Attached please find my documents in response to the concern surrounding the installation of traffic barriers at Heritage Corner.

## A plea to restore our Heritage Corner.

**Re: Review of concrete box installation Heritage Corner.**

**Traffic Barriers Heritage Corner Longford.**

### **Option 3: Barrier Protecting Sticky Beaks Café Building**

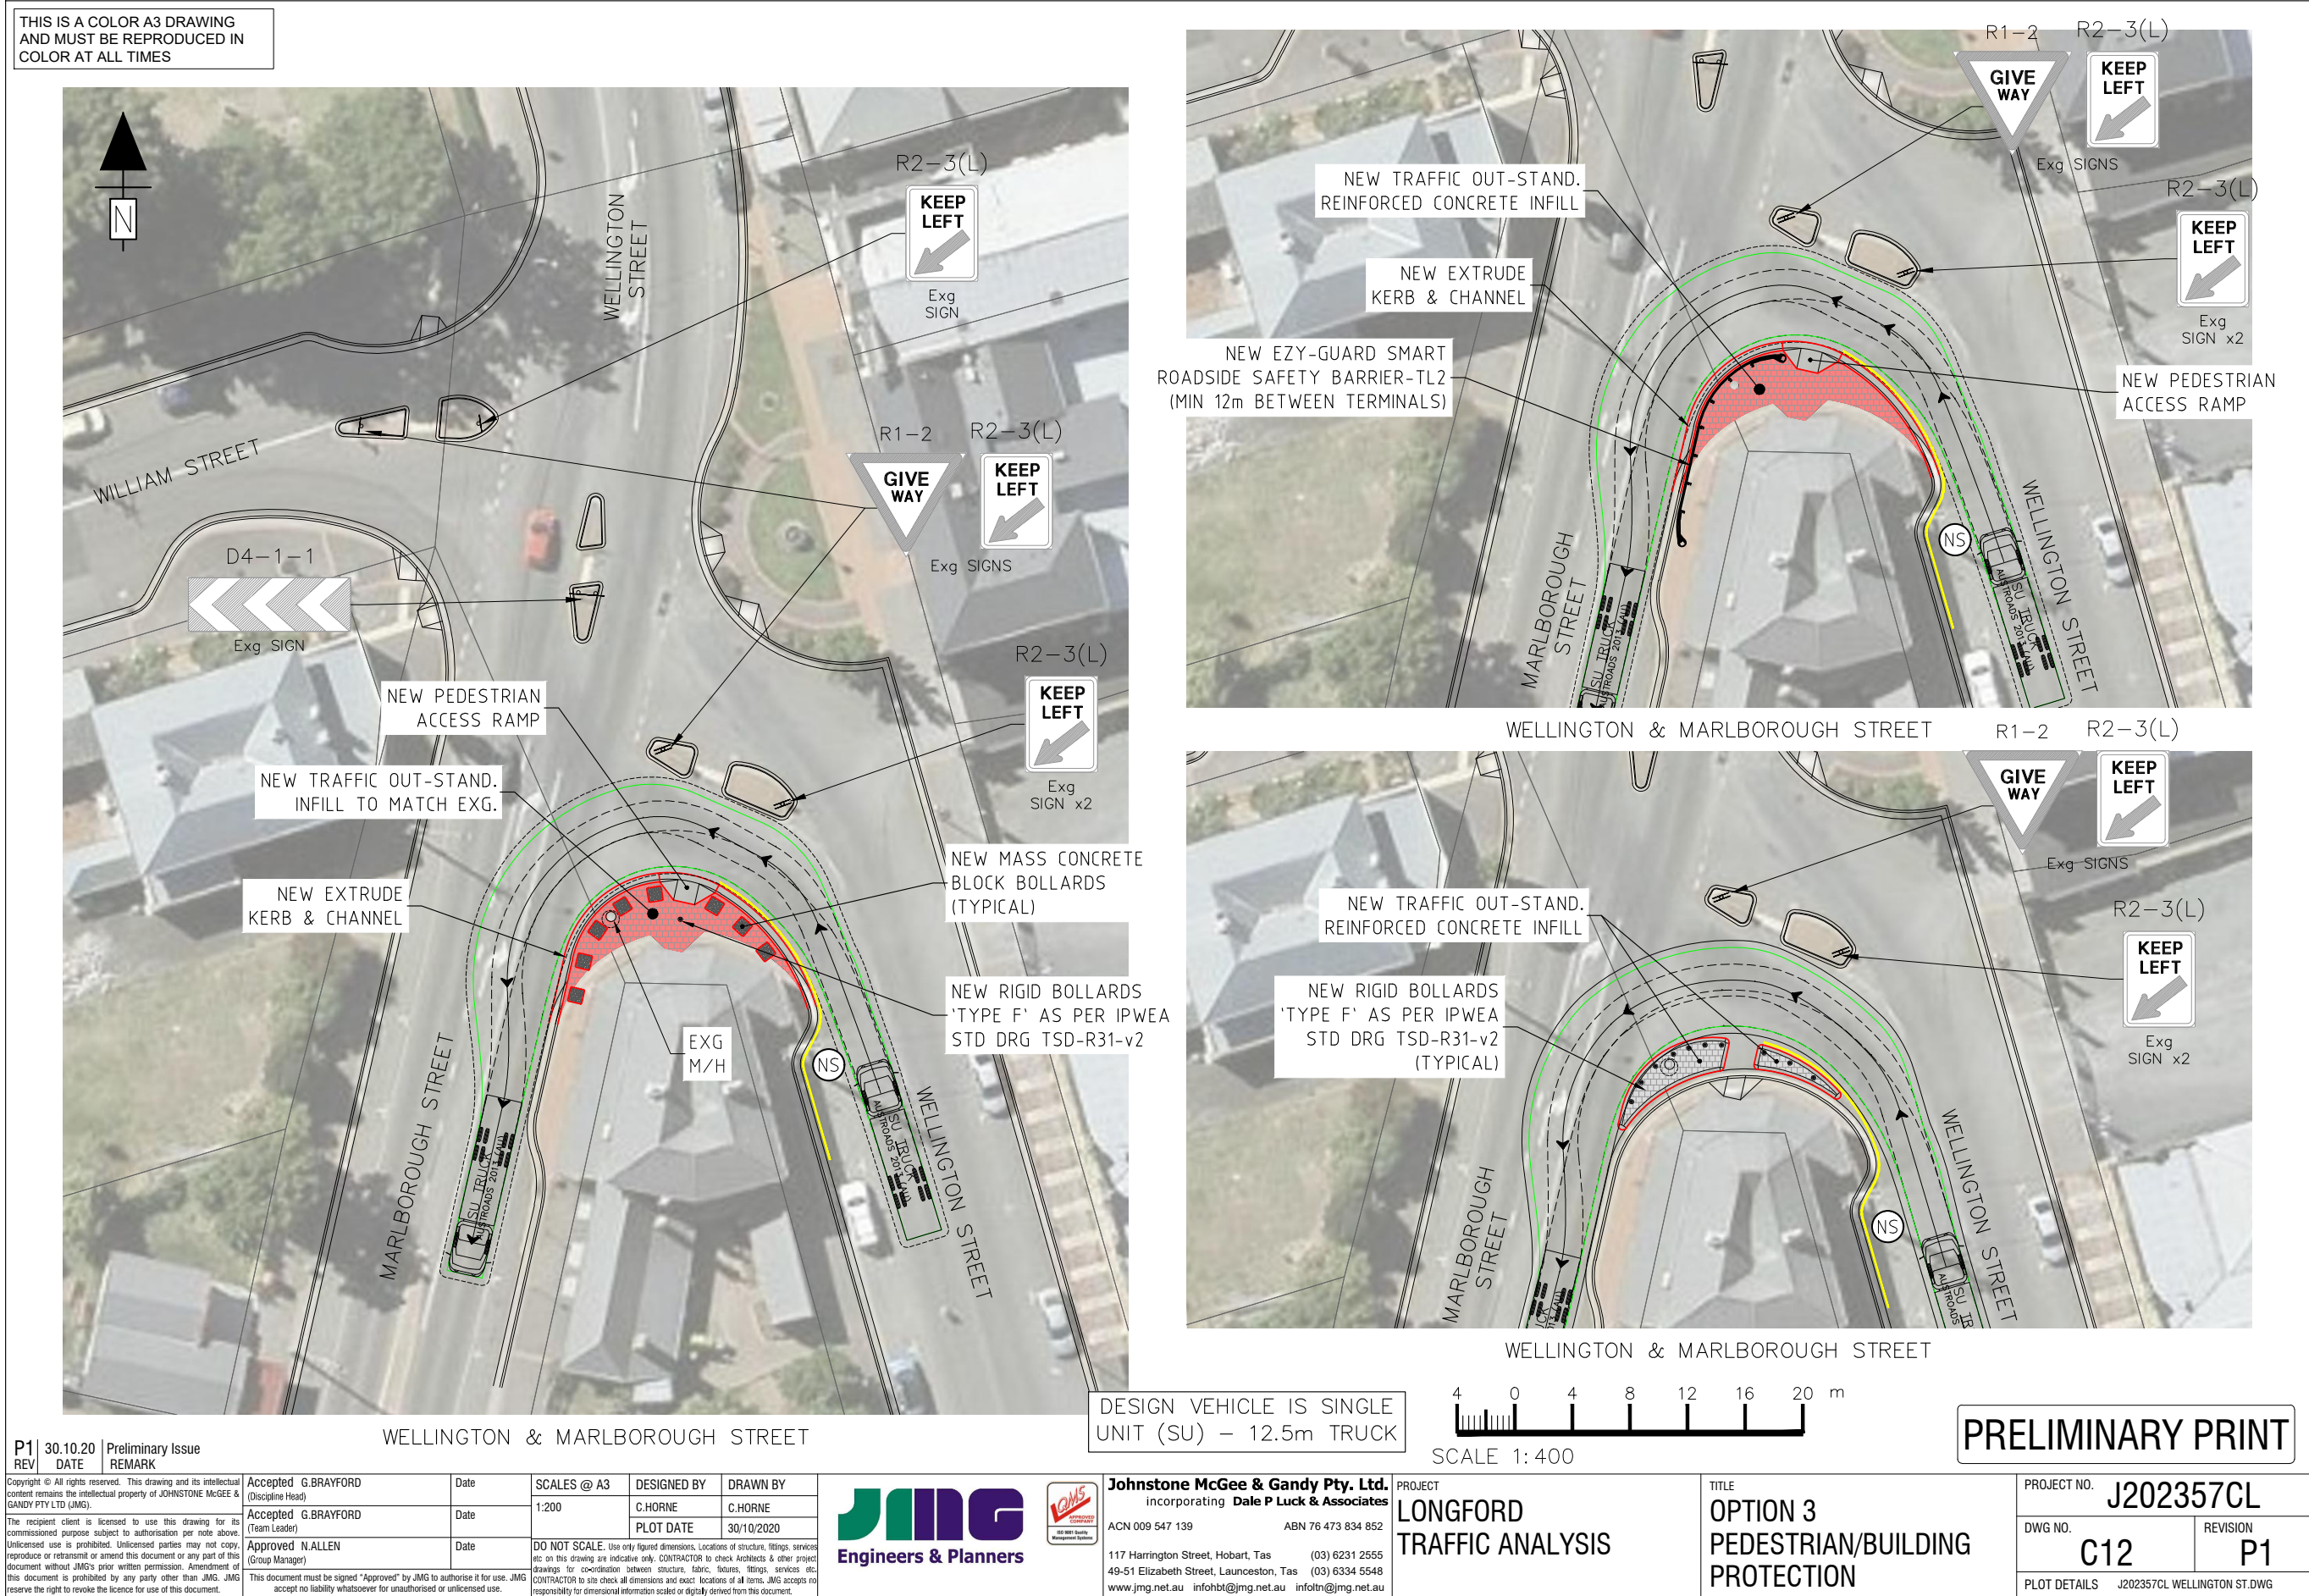
In relation to the use of the 1300mm by 1300mm cement boxes, which appear to be 'civil works risers' or adapted 'inspection pit items' from Hudson Civil; there does not appear to be any provision for this type of barrier in either AustRoad, VicRoads or TasRoads recommendations or specifications.

The JMG work drawings show a 2.2 meter '**vehicle penetration zone**' past the edge of the concrete box. The drawing also shows a '**major debris zone**' of 6.5meters past the footpath of the concrete box to the Sticky Beaks exterior wall.

The above 'debris zone' extends to the Sticky Beaks exterior wall and includes the restaurant main front window. It is presumed that the debris in the 6.5m debris zone would include vehicle components and flying concrete?

As the concrete boxes are half filled with additional concrete, and the boxes are just sitting inside, what appears a 120 mm to 150 mm hole, with apparently no connecting steel reinforcing tie rods or structural anchors, the potential for the boxes to dislodge and skate over the smooth pavement and hitting the Sticky Beaks exterior wall can not be discounted.
